**TOWN OF HERNDON, VIRGINIA
ARCHITECTURAL REVIEW BOARD WORK SESSION AGENDA
AUGUST 3, 2022
HERNDON MUNICIPAL CENTER
LARGE CONFERENCE ROOM, 2nd Floor
777 LYNN STREET
7:30 P.M.**

Title: ARB #22-018; New signage and awning alteration; 1142 Elden Street, 1100 Herndon Parkway

Subject: Pre-application ARB Discussion Item, DPA #21-01, 555 Herndon Parkway

Subject: Pre-application ARB Discussion Item, DP #21-01, 555 Herndon Parkway

PHASE I. - INTERIM CONDITION

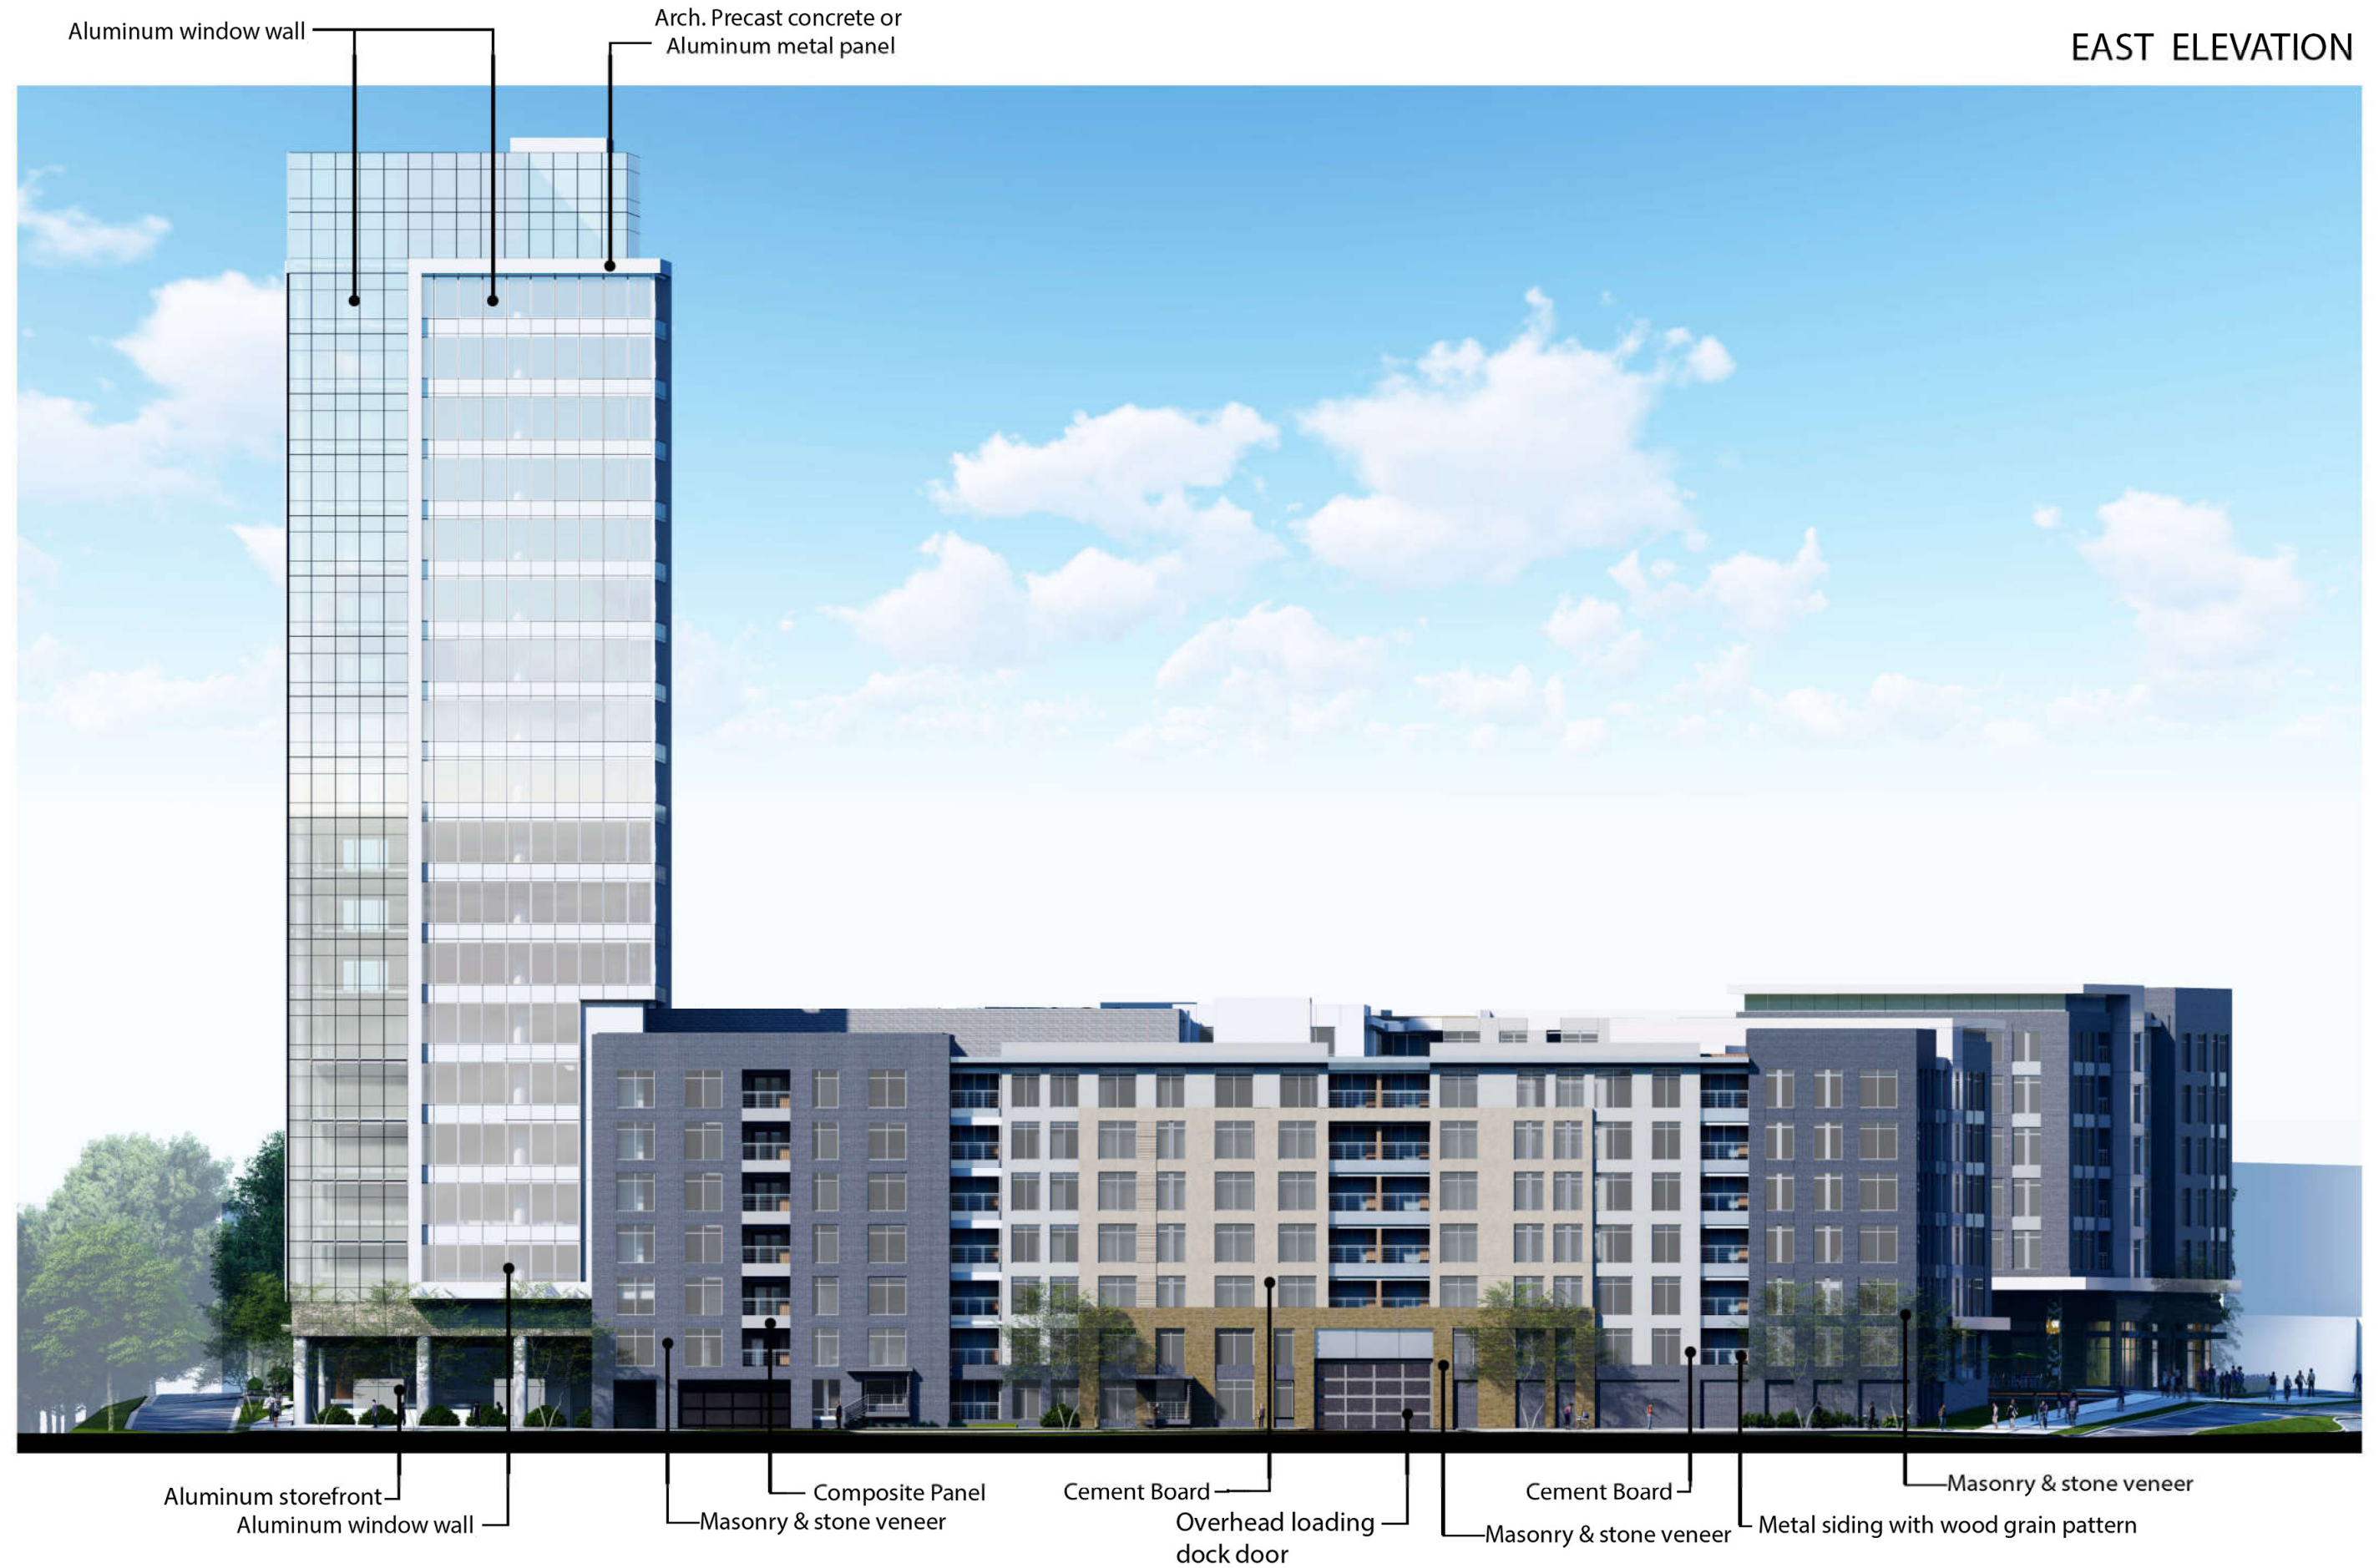
The applicant has made it clear that there will be two phases of this development, the first of which will not include the office tower. In this interim state, the footprint on the south side of the block that will later be occupied by the tower will initially be used as open space/pedestrian area. The residential building parking garage, eventually to be located behind the office tower, will not be hidden from view but will face the open space and the Dulles toll road. Renderings of this area in phase one can be seen on page 16 of the attached renderings. The proposed façade treatment here consists of mostly EIFS, a faux stucco cladding material that has traditionally been highly discouraged within the Town of Herndon for uses other than small details. The EIFS clad area extends beyond the garage to clad the blank façade of the residential units next door. The garage openings are large and without any screening.

Staff is concerned that there is very little treatment of this area to make it more visually interesting and that there is no screening of any kind on the garage façade. As this will be facing public right of way and open space for an unforeseen time, more concentration should be focused on this area to find ways to make it visually interesting: color differentiation, variety of textures and materials, and screening of some kind. Staff will be providing visual examples of garage screening treatments at the work session which could be considered for this area.

Garage screening is of course an important issue that has been previously raised regarding HTOC development. As mentioned above, the current elevations and material description indicate that the levels of parking above the office building lobby will be readily apparent. In addition, if the office building is not built at the same time as the residential, the south façade of the residential parking garage will be visible, and screening will be needed.
